## **ROSEN SUBDIVISION**

Engineering Comments: Final Plat Comments (should be addressed prior to submitting the FINAL PLAT for acceptance and signature by the City Engineer):

# DETAIL SITE PLAN

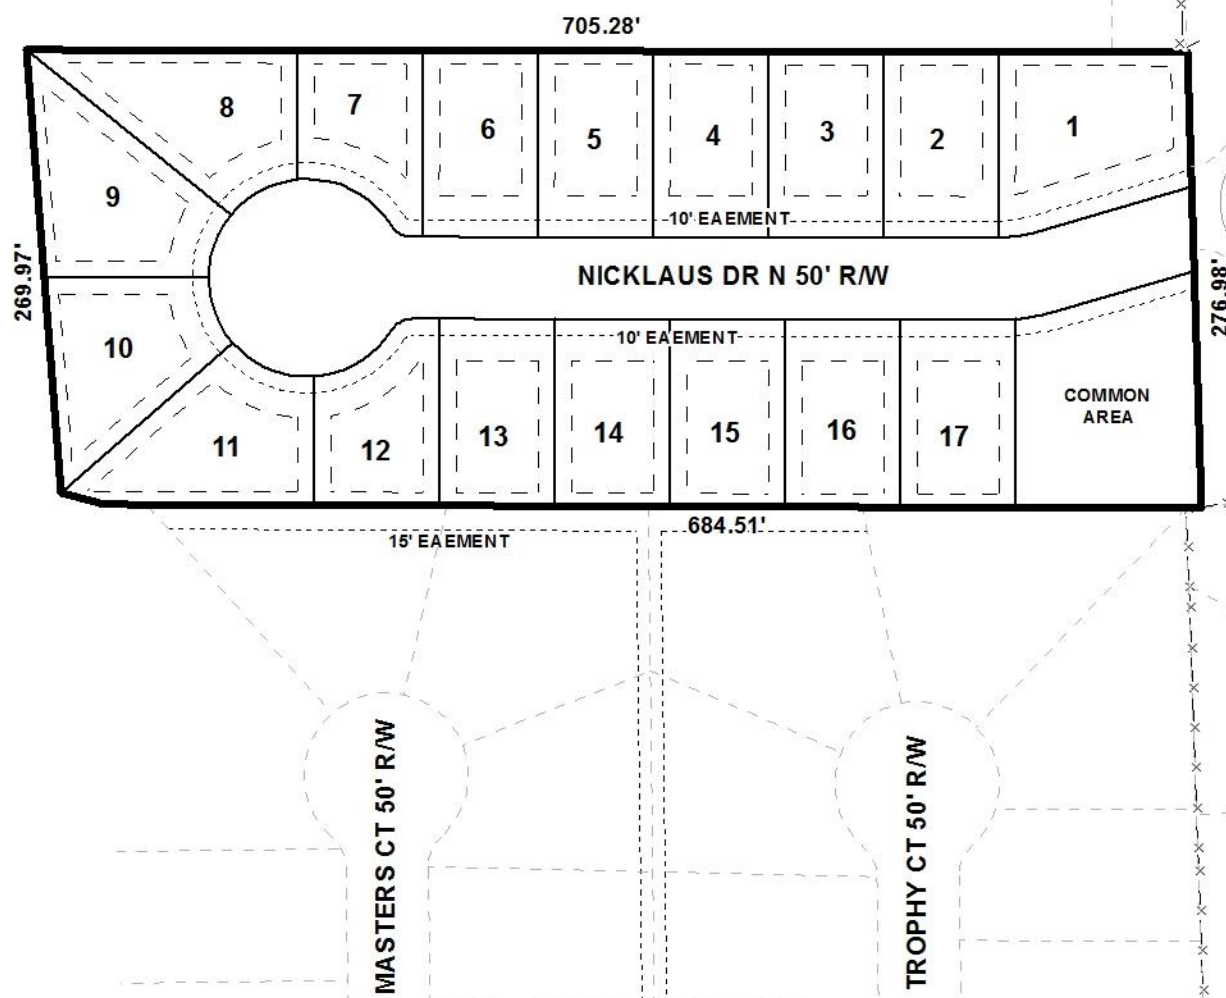
- B. Show and label the offsite drainage easements and drainage features along the south boundary line with existing lots 22, 23, and 37.
- C. The minimum ROW width required (50') is not being provided where connecting to the existing Nicklaus Drive North ROW. It appears that there will only be 38 feet provided for ROW. Provide an updated Plat for review after revising the centerline to meet the requirements the Subdivision Regulations.

- D. Show and label adequate drainage easements along the rear of Lots 9 – 17 as needed to transport drainage to the detention pond/common area.
- E. Provide a copy of the proposed restrictions and covenants.

- F. Provide and label the monument set or found at each subdivision corner.
- G. Correct the typo contained in the name of the proposed subdivision "Rosen Subdivision Plat 1".

Traffic Engineering Comments: Centerline extension from the existing Nicklaus Drive N alignment and offset right-of-way, does not allow for adequate construction of a city standard street at the east end of the property. Provide an updated plat as needed to improve the right-of-way width and roadway alignment. Driveway number, size, location and design to be approved by Traffic Engineering and conform to AASHTO standards.

The site abuts The Legends at Magnolia Grove Subdivision, Unit 2 and is connected to Nicklaus Drive North, a minor street, with an adequate 50' right-of-way. It should be noted that this subdivision will only have one point of access until another phase is developed or an adjacent property is developed. It should also be noted that the proposed street is offset from the existing Nicklaus Drive North right-of-way, resulting in a right-of-way width problem.

All of the lots, with the exception of Lot 7 will exceed the 7,200 square feet minimum lot size requirements. no justification was provided regarding Lot 7 only being 7,012 square feet, thus the plat should be modified to ensure that all lots meet the minimum 7, 200 square feet requirement, and that the minimum building setback line is placed where the lots are at least 60 feet in width.

The 25' minimum building setback line is not clearly labeled on the preliminary plat however; a note stating a "25' front, 8' rear, and a 10' minimum building set back is depicted on the preliminary plat. If approved, revisions should be made on the Final Plat to depict the 25' minimum building setback line.

There is a 10' utility easement that is located in the front of each lot. A note should be placed on the Final Plat stating that no structures shall be constructed or placed within any easements.

The cul-de-sac diameter appears to be in compliance with Section V.B.14. of the Subdivision Regulations, and should be retained on the Final Plat.

A common area is depicted on the preliminary plat; therefore, a note should be placed on the Final Plat stating maintenance of these areas will be the responsibility of the property owners.

Based on the preceding, this application is recommended for Holdover until the September 1, 2016 meeting with revisions due by August 16<sup>th</sup>, to allow the applicant to address the following:

- 1) revision of the site plan to address the right-of-way width issue; and
- 2) revision of the site plan to depict all lot sizes to be a minimum of 7,200 square feet.
